**ADDENDUM FOR  
TENDER NO: MOICT/SDICT/ONT/011/2021-2022**

**TENDER FOR SUPPLY, INSTALLATION AND COMMISSIONING OF  
NETWORK INFRASTRUCTURE  
AT NAROK LEVEL IV COUNTY REFERRAL HOSPITAL, NAROK COUNTY**

**ISSUE DATE: 23<sup>RD</sup> AUGUST, 2021**

# NAROK COUNTY REFERRAL HOSPITAL ADMINISTRATION/PUBLIC HEALTH PROPOSED NETWORK LAYOUT

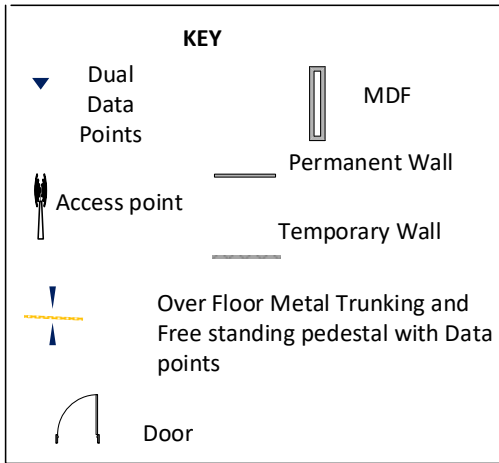
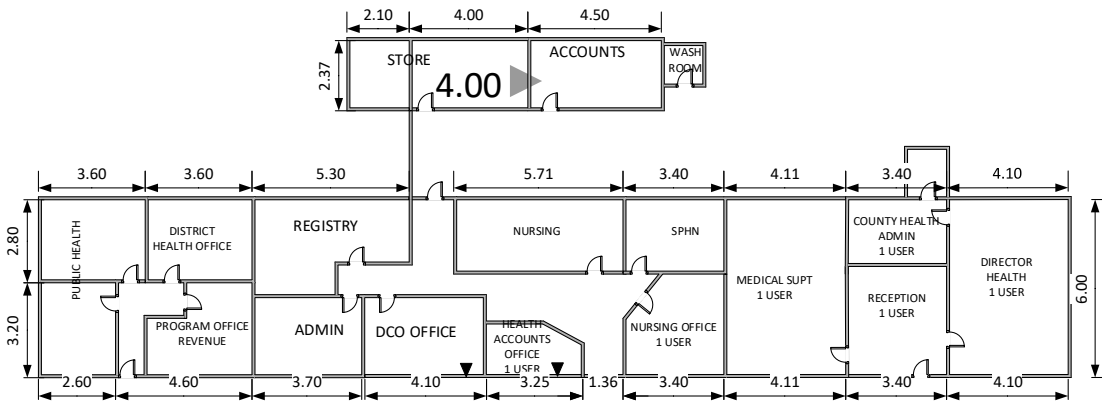
3.	<p>The following blocks have existing LAN:</p> <ul style="list-style-type: none"> <li>a. Administration/ Public Health Block</li> <li>b. CCC</li> <li>c. Pediatrics &amp; Adolescent Center</li> </ul>	<p>There will be no new installation of the structured cabling Network in these Blocks but ports will be repaired and added where necessary.</p> <p>Optic Fiber cable shall be pulled to integrate with the new network</p> <p>The Bill of Materials, Price Schedule and network designs drawings have been amended to accordingly to reflect the new requirements as specified in section 3.0, 4.0 and 5.0 of this Addendum.</p>

**Existing Data Points= 28**  
**Additional Data Points=4**

## NAROK COUNTY REFERRAL HOSPITAL CASUALTY PROPOSED NETWORK LAYOUT

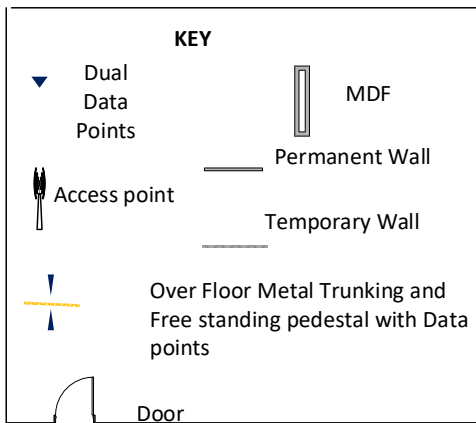
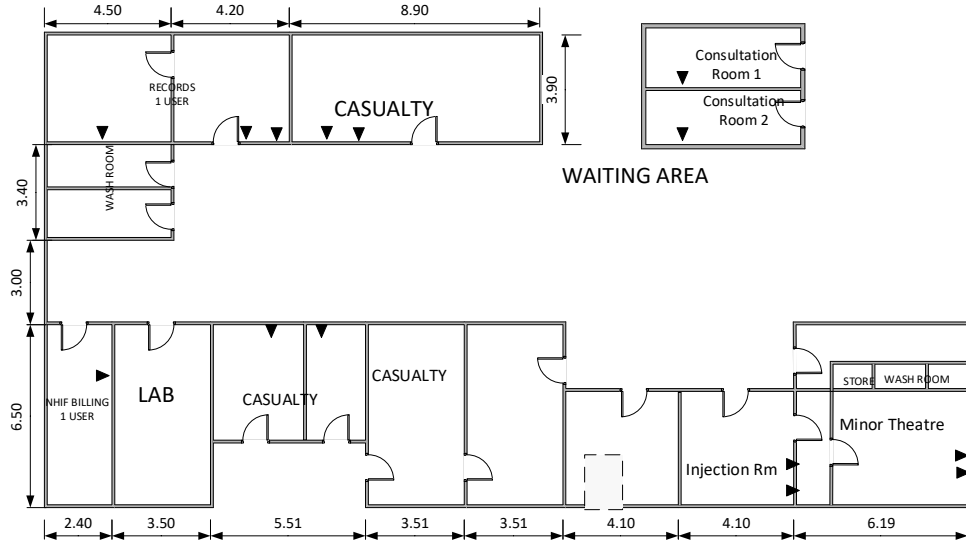
No.	ISSUES THAT CAME UP	CLARIFICATION
1.	<p>The following blocks were reorganized and new service points added:</p> <ul style="list-style-type: none"> <li>a. Casualty Block</li> <li>b. Renal/ICU</li> <li>c. Radiology</li> <li>d. Laboratory (Lab)</li> <li>e. Dental/ Health Records</li> <li>f. Maternity</li> </ul>	<p>The Bill of Materials, Price Schedule and network designs drawings have been amended to accordingly to reflect the new requirements as specified in section 3.0, 4.0 and 5.0 of this Addendum.</p>

**Existing Data Points= 12**  
**Additional Data Points=28**

NAROK COUNTY REFERRAL HOSPITAL  
CT SCAN  
PROPOSED NETWORK LAYOUT

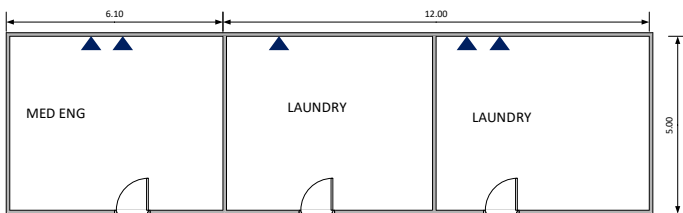
5.	<p>There exists a network serving the Imaging CT-Scan, CHMT, Walter Reed Department. The existing active devices are not POE.</p>	<p>The Bill of Materials and Price Schedule have been amended to accordingly to reflect the new requirements as specified in section 3.0 and 4.0 of this Addendum.</p> <p>Optic Fiber cable shall be pulled to integrate with the new network</p>

**Existing LAN  
Link to the Aggregation Switch**

NAROK COUNTY REFERRAL HOSPITAL  
LAUNDRY/BIOMED/OXYGEN  
PROPOSED NETWORK LAYOUT

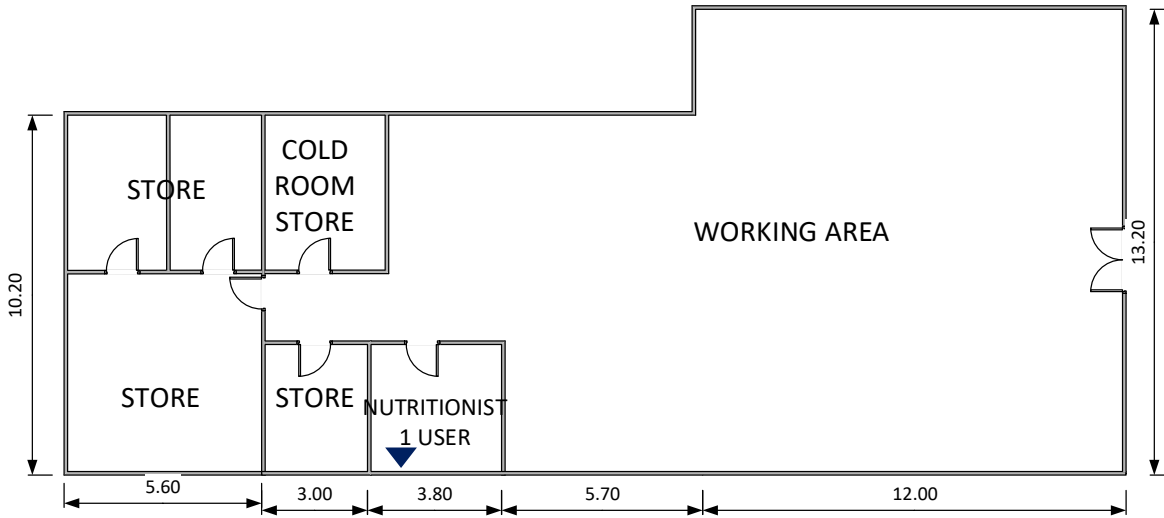
2.	<p>The following blocks did not have data points indicated in the drawings:</p> <ul style="list-style-type: none"> <li>a. OPD</li> <li>b. Blood bank</li> <li>c. Laundry/ Biomed</li> <li>d. Health Records</li> <li>e. Morgue</li> </ul>	<p>The Bill of Materials, Price Schedule and network designs drawings have been amended to accordingly to reflect the new requirements as specified in section 3.0, 4.0 and 5.0 of this Addendum.</p>

**Data Points=12**

NAROK COUNTY REFERRAL HOSPITAL  
CHEST/EYE CLINIC  
PROPOSED NETWORK LAYOUT

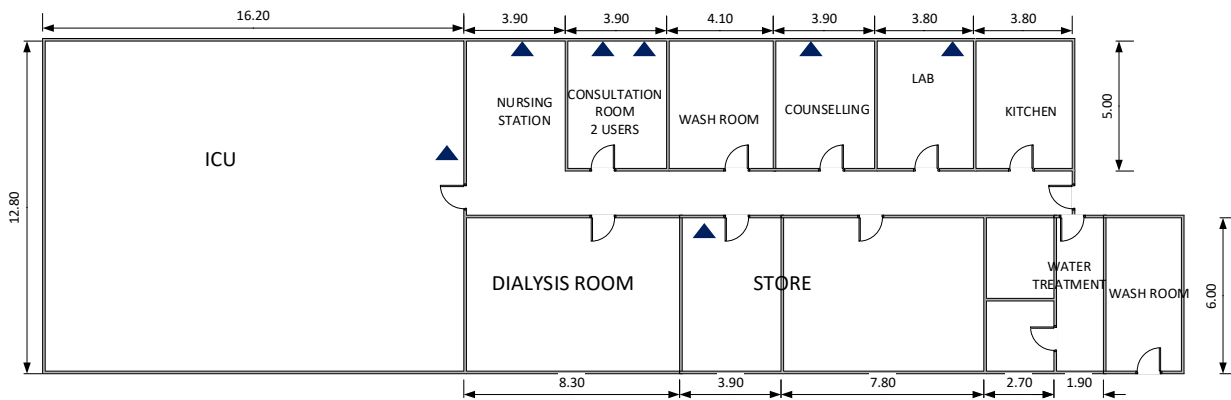
4.	<p>The drawings of the following Blocks were missing from the Tender Document:</p> <ul style="list-style-type: none"> <li>a. Chest clinic Block</li> <li>b. Boardroom</li> <li>c. HR Container</li> </ul>	<p>The Bill of Materials, Price Schedule and network designs drawings have been amended to accordingly to reflect the new requirements as specified in section 3.0, 4.0 and 5.0 of this Addendum.</p>

**Data Points=30**
